WORCESTER TOWNSHIP PLANNING COMMISSION

PRELIMINARY / FINAL PLAN – HEALTH CARE NORTHEAST EXPANSION
COVER – INDEX SHEET
MEADOWOOD SENIOR LIVING
WORCESTER TOWNSHIP – MONTGOMERY COUNTY – PENNSYLVANIA
WOODROW & ASSOCIATES, INC.
MUNICIPAL / CIVIL CONSULTING ENGINEERS
1108 North Merkle Street, Suite 200
Pottsville, PA 17860
Phone: (717) 542-6648 Web: www.Woodrowinc.com

PRELIMINARY / FINAL PLAN - HEALTH CARE NORTHEAST EXPANSION
RECORD PLAN - OVERALL TRACT
MEADOWOOD SENIOR LIVING
WORCESTER TOWNSHIP - MONTGOMERY COUNTY - PENNSYLVANIA

PROFILE: STORM MANHOLE D110 TO OUTLET STRUCTURE D105

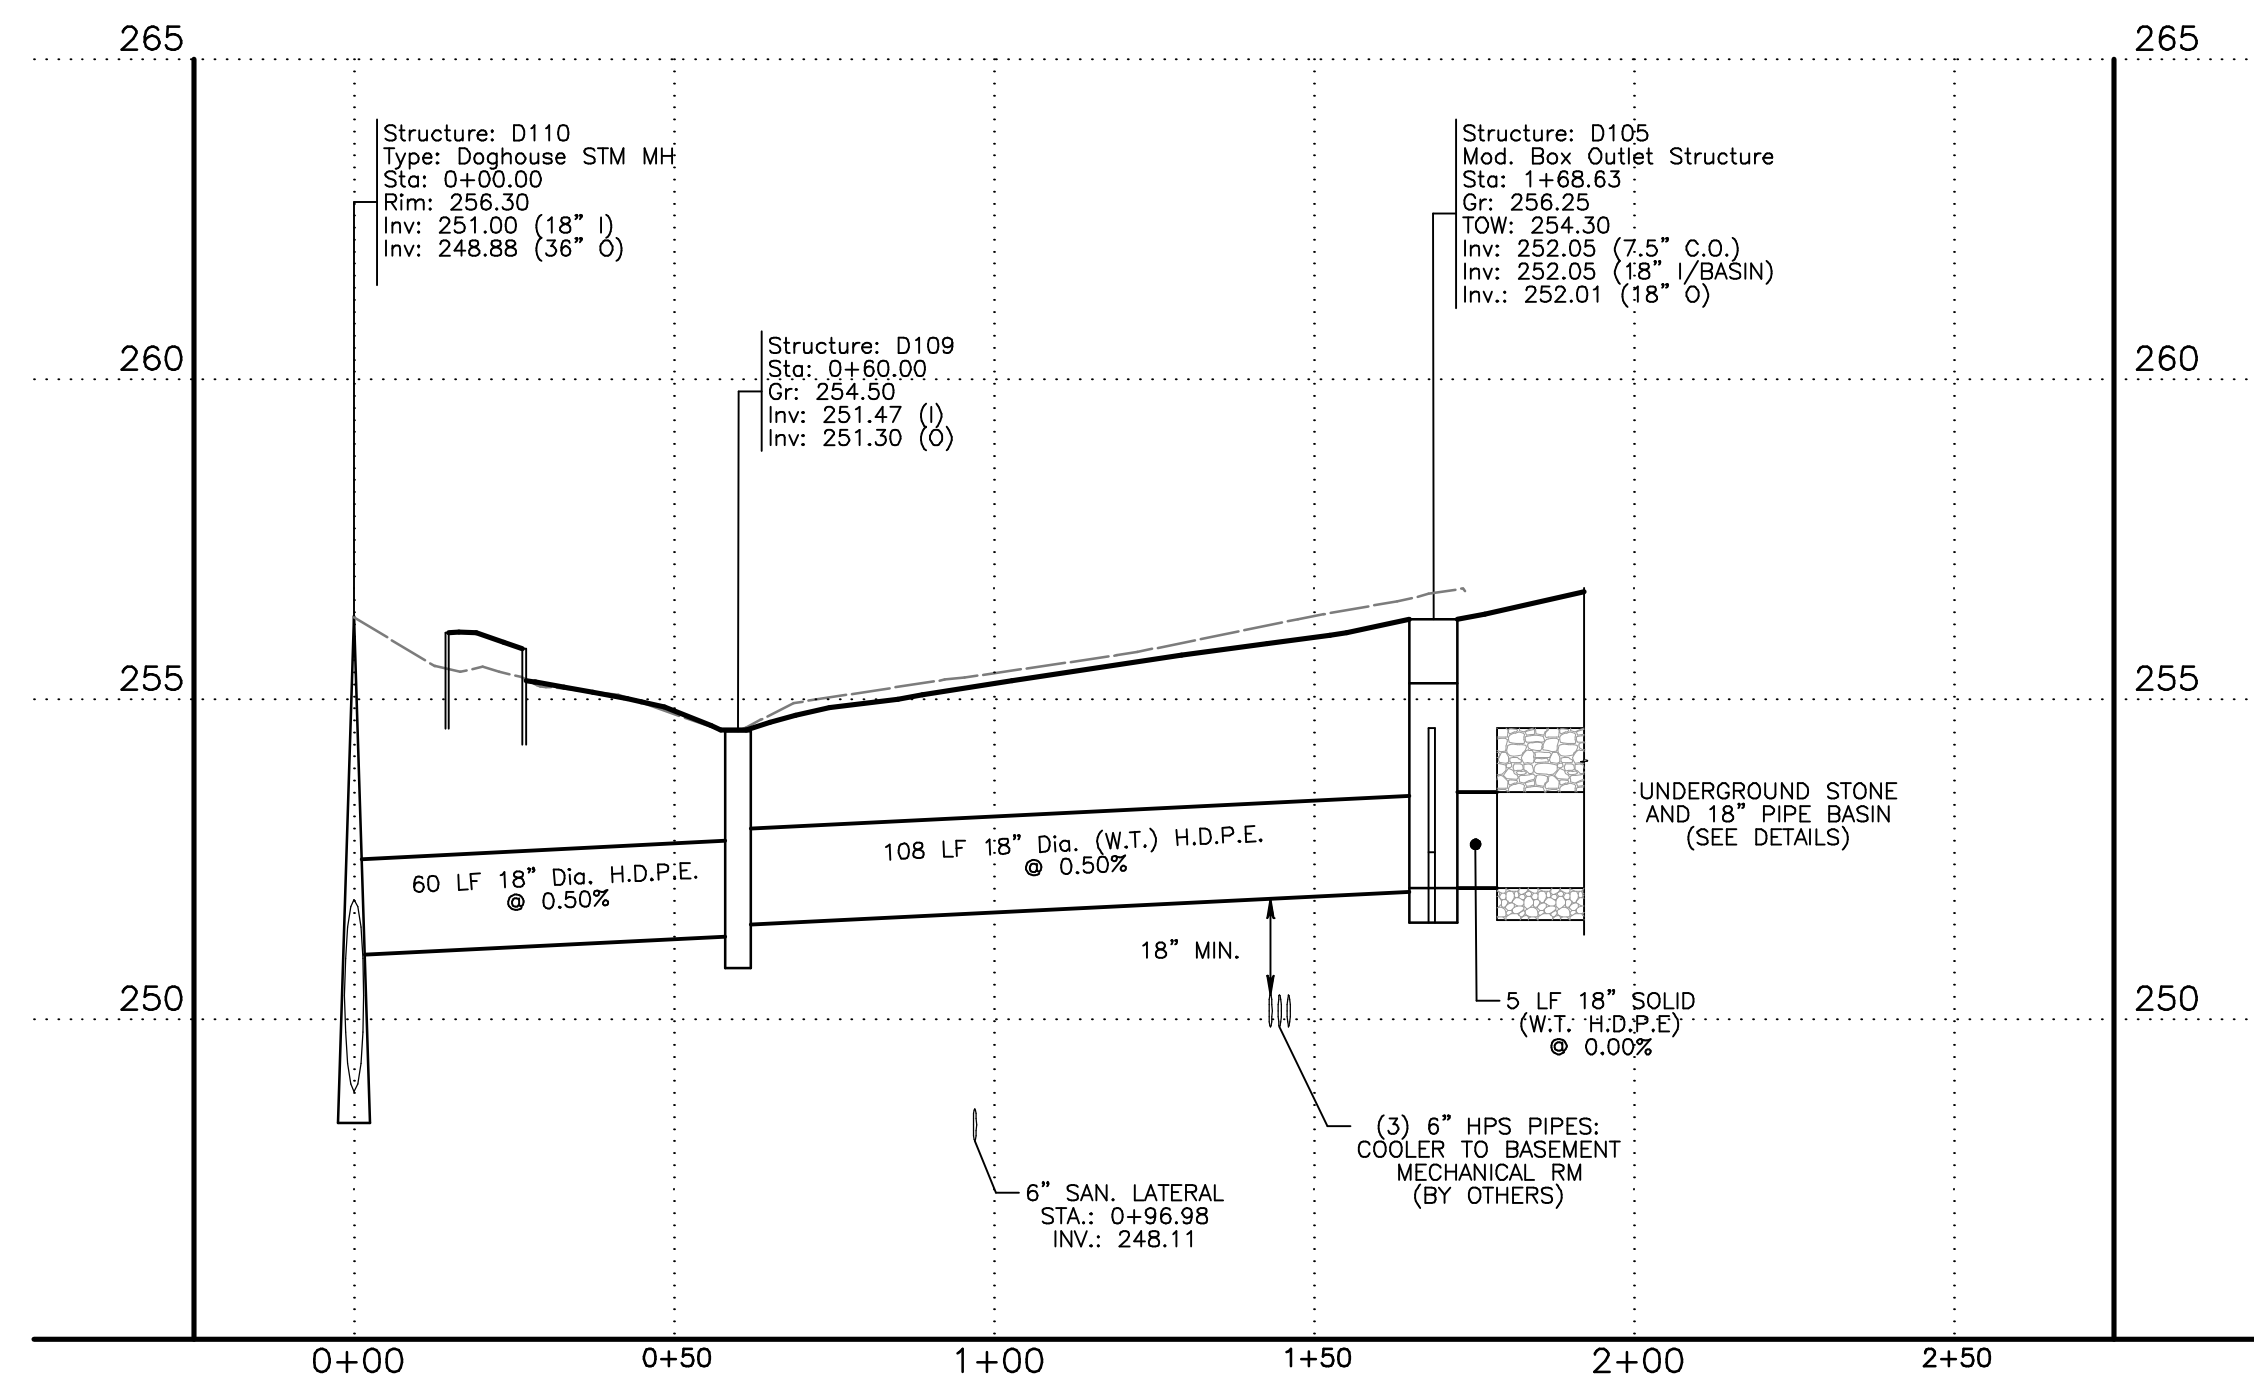
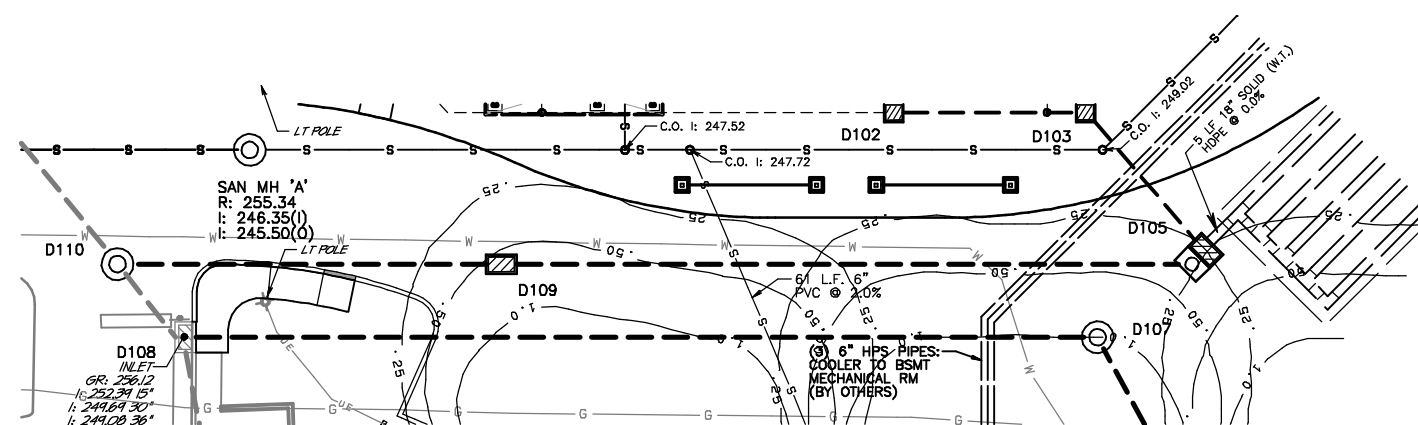
4. *On both Sheet 6 and Sheet 9, there is a missing invert for structure D104.*

5. *Sheet 6 has a rim elevation for Manhole D105 of 255.73 and Sheet 9 has a grate elevation of 255.66. The plans must be revised accordingly.*

14. Inlet D106 must be shown on the profiles on Sheet 9. (130-33.F.1)

1. The sanitary lateral profile on Sheet 9 only shows one "proposed" segment of PVC; however, it is our understanding that all portions shown in the profile will be newly installed. The labeling and line weights should be adjusted accordingly.

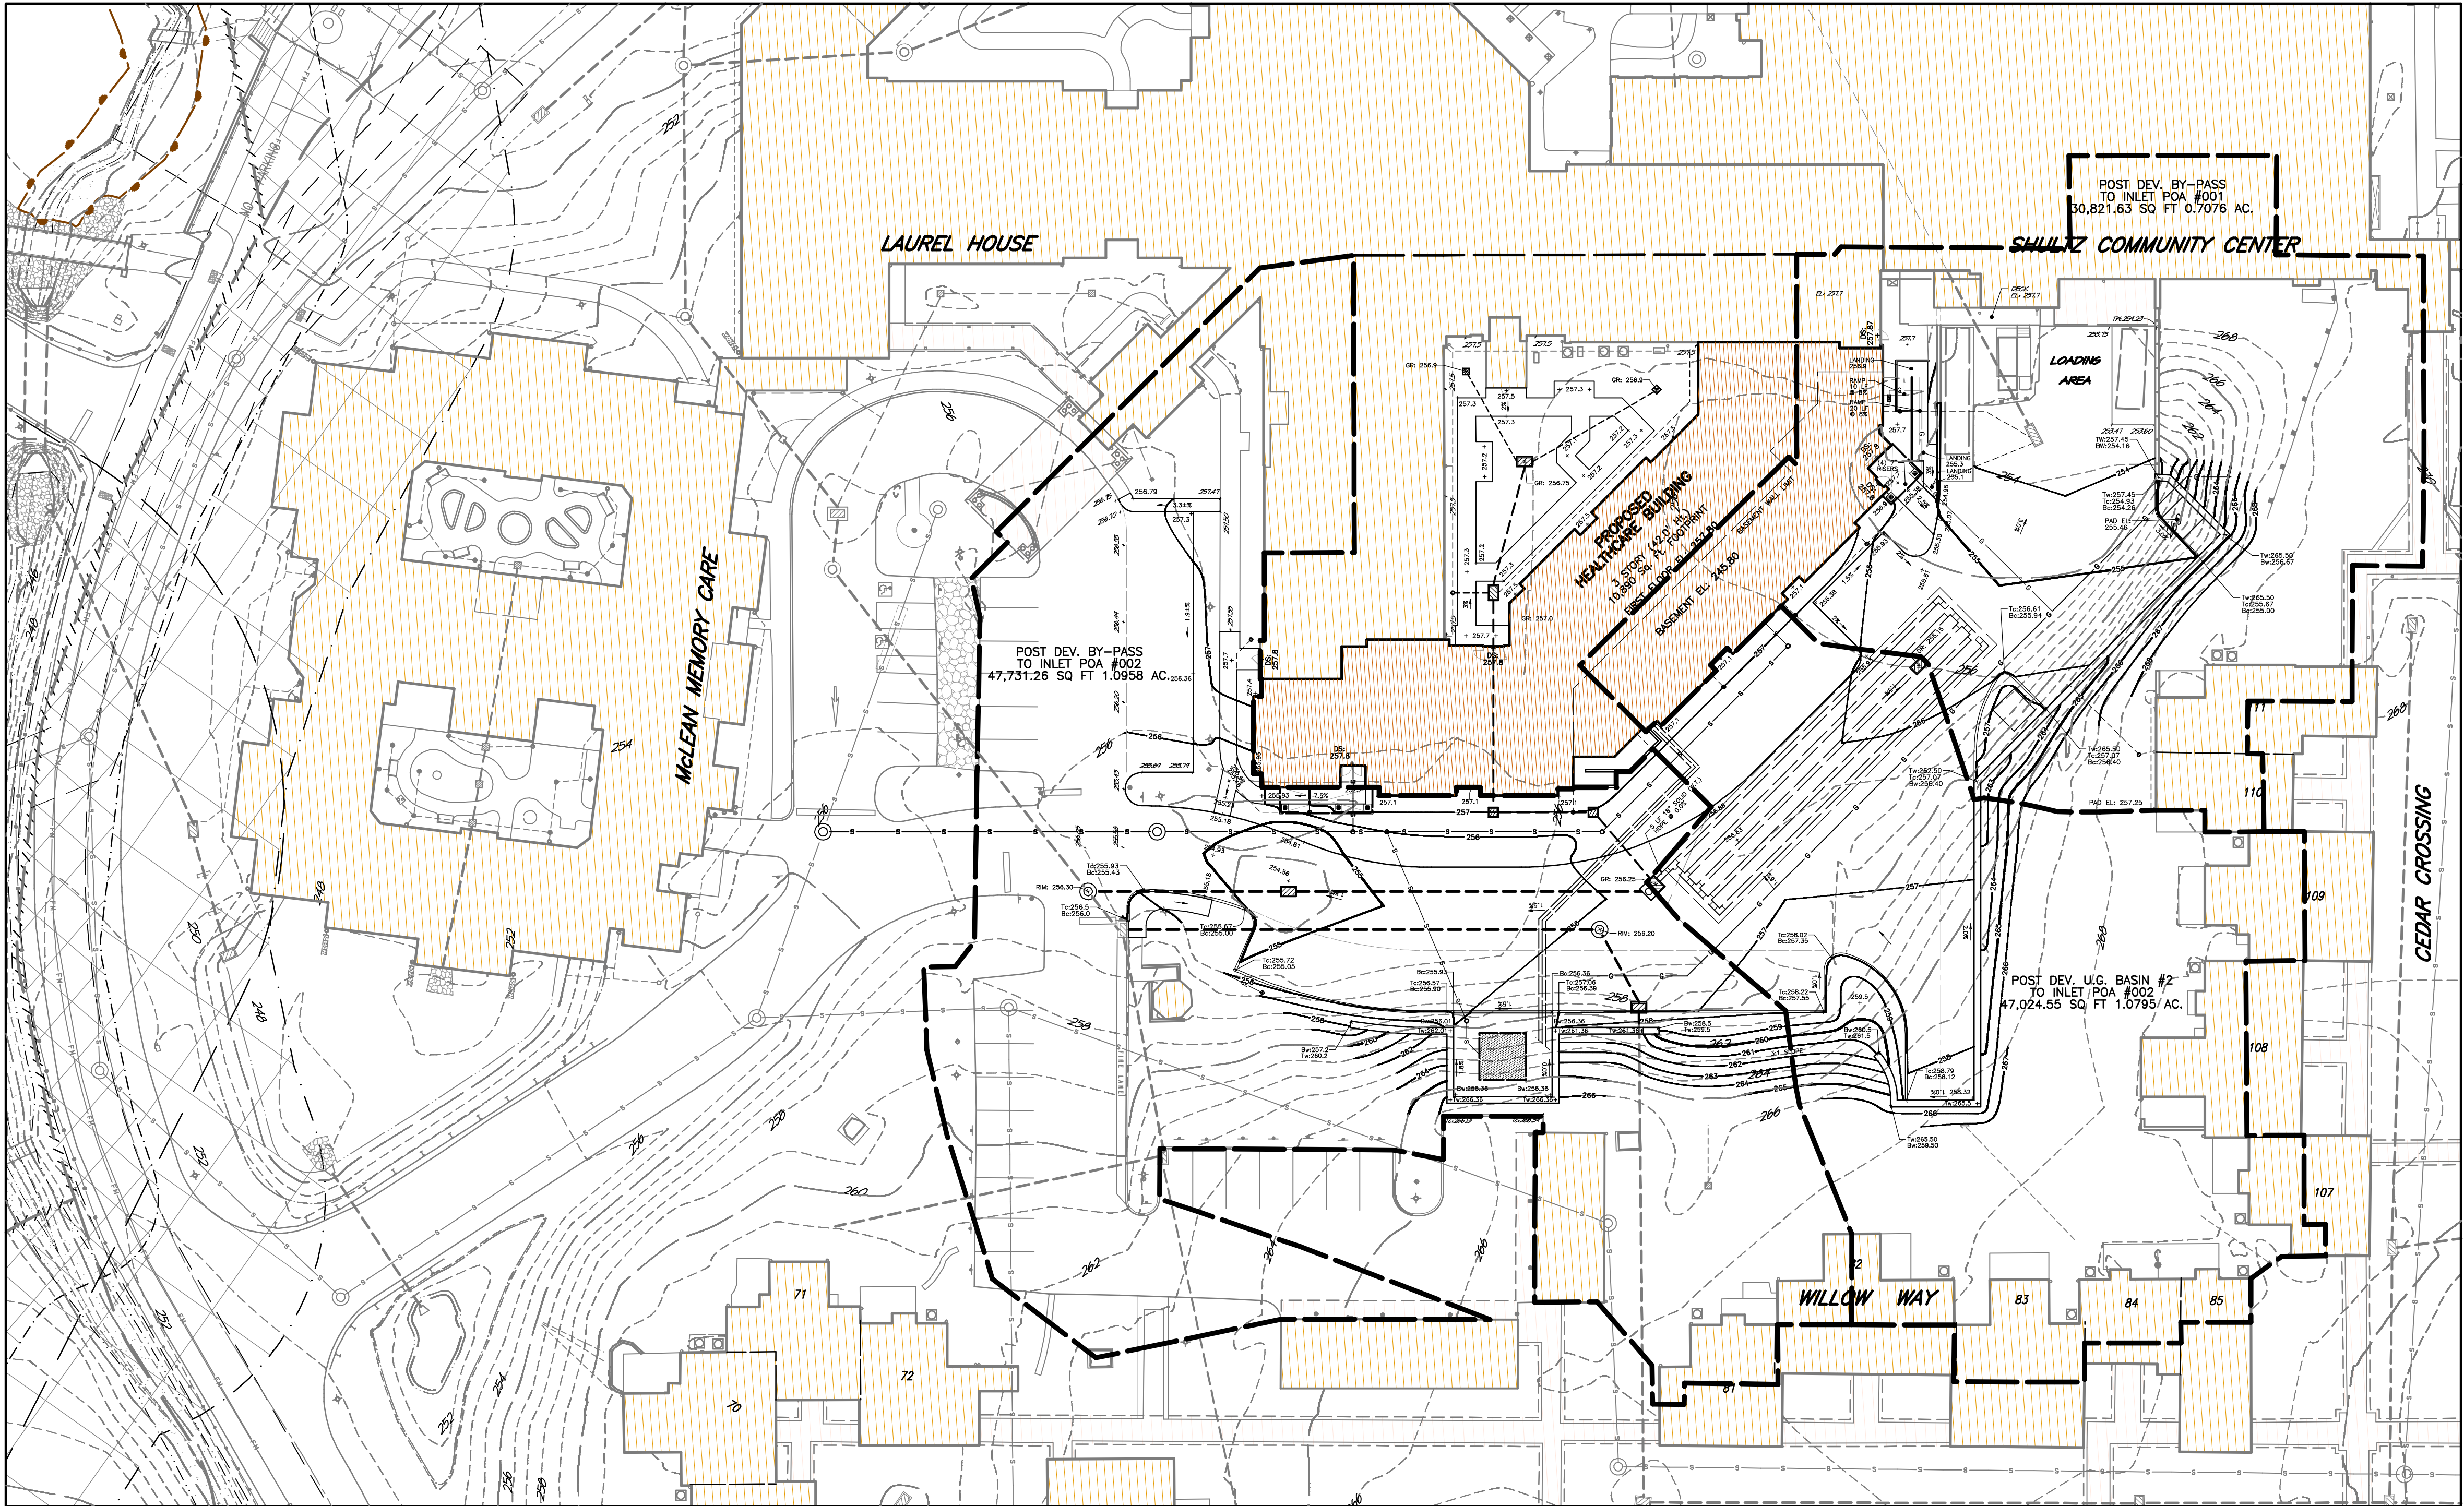
6. *All proposed erosion and sediment controls must be added to the plan on Sheet 12.*

5. All proposed erosion and sediment controls must be added to the plan on Sheet 12. While the construction sequence is still being coordinated with the property owner, the plan could still be revised to show inlet filter bags, compost filter sock, and tree protection fencing at a minimum. (129-12.F and 129.20)
